DANE COUNTY DEPARTMENT of PUBLIC WORKS, HIGHWAY and TRANSPORTATION

RFB NO. 309025 - ADDENDUM NO. 1

GAS COMPRESSOR BUILDING

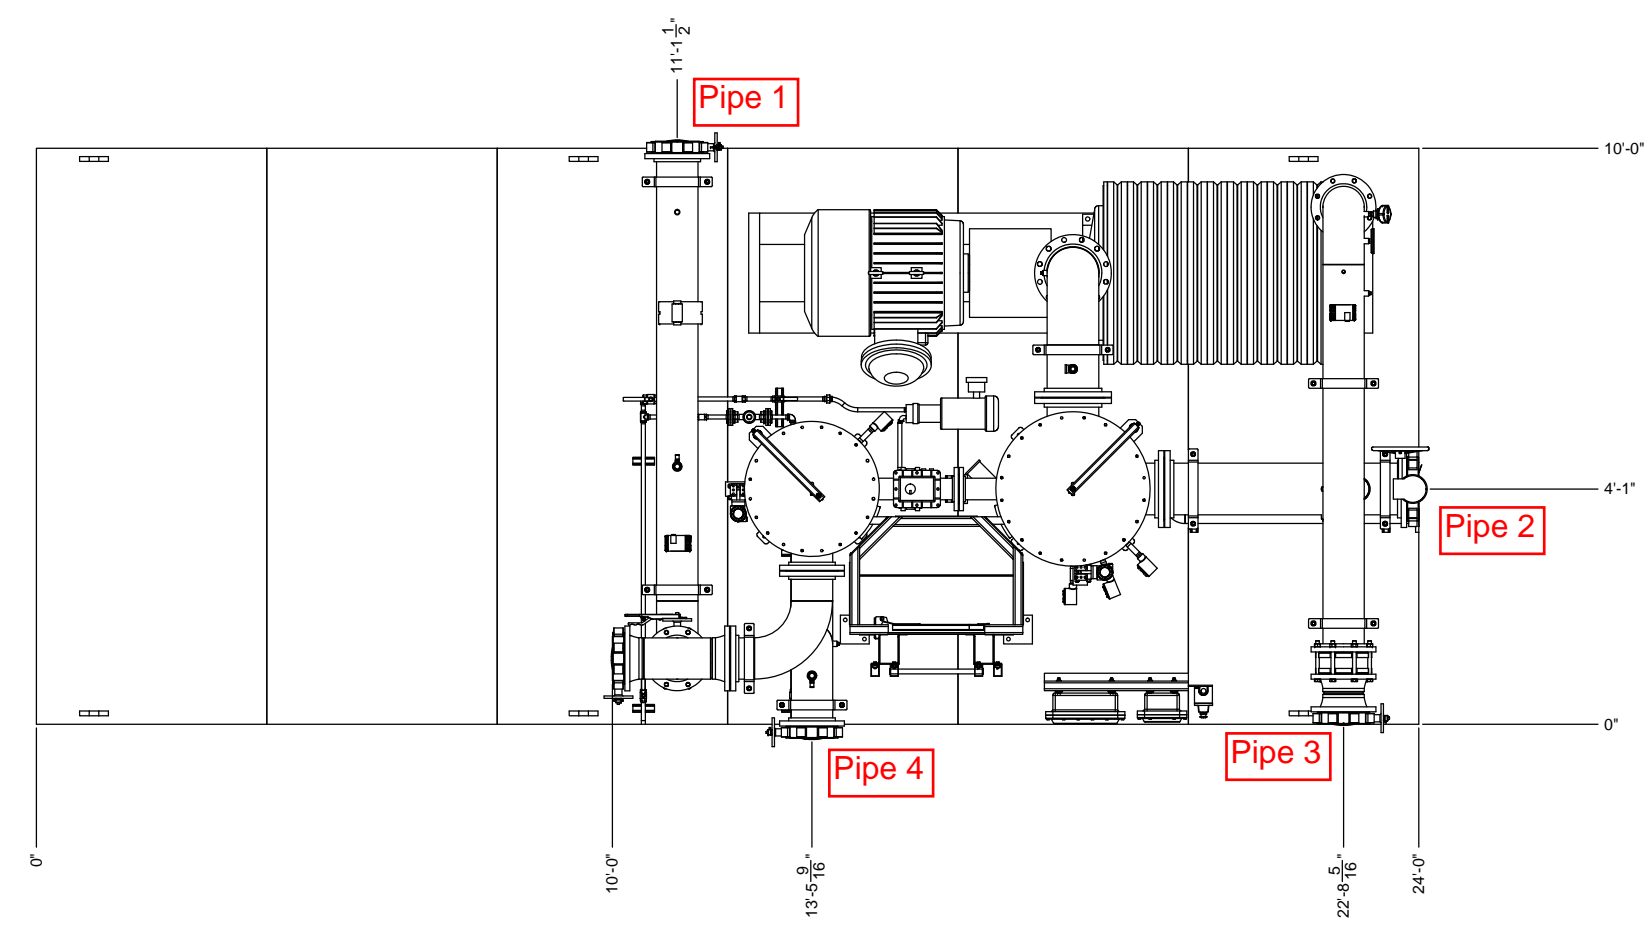
The roll-up doors are located as indicated on the attached Drawing 7.

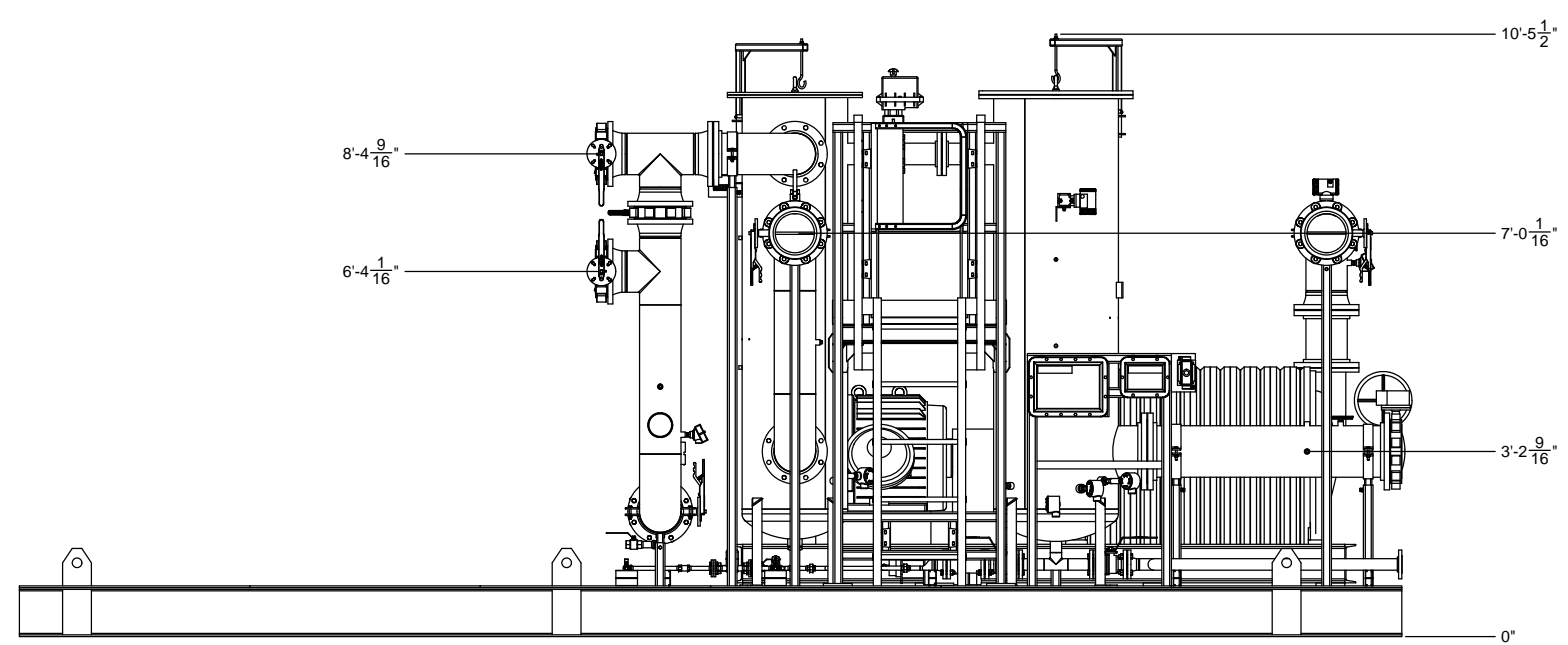
Gas compression equipment, located on a skid, will be installed on the concrete slab prior to Work for this contract. Drawing 6, which shows the dimensions of this equipment, is attached to this addendum.

This equipment is used to clean and compress methane gas that is pulled from the landfill, and there is up to 1300 SCFM of gas running through the pipes at all times. This equipment will be running while the building is constructed around the gas skid, but the gas equipment can be shut down for short periods of time if absolutely necessary to complete this Work. It

This building must have an interior clear height of at least 16' at all locations directly above the gas compression skid. This clearance is needed for Dane County staff to perform maintenance on the equipment.

As part of this contract, four (4) pipes associated with the gas compression equipment will need to be supported by brackets attached to the roof framing members of the building. Once the pipes are outside of the building, braces coming up from the ground will support them. Dane County will install the ground supports. These four pipes are indicated on the attached Drawing 6 of the gas compression equipment. All of this piping will be 8" Schedule 10. Their weight is 13.7 lb/ft. Design the building to be able to handle this loading.
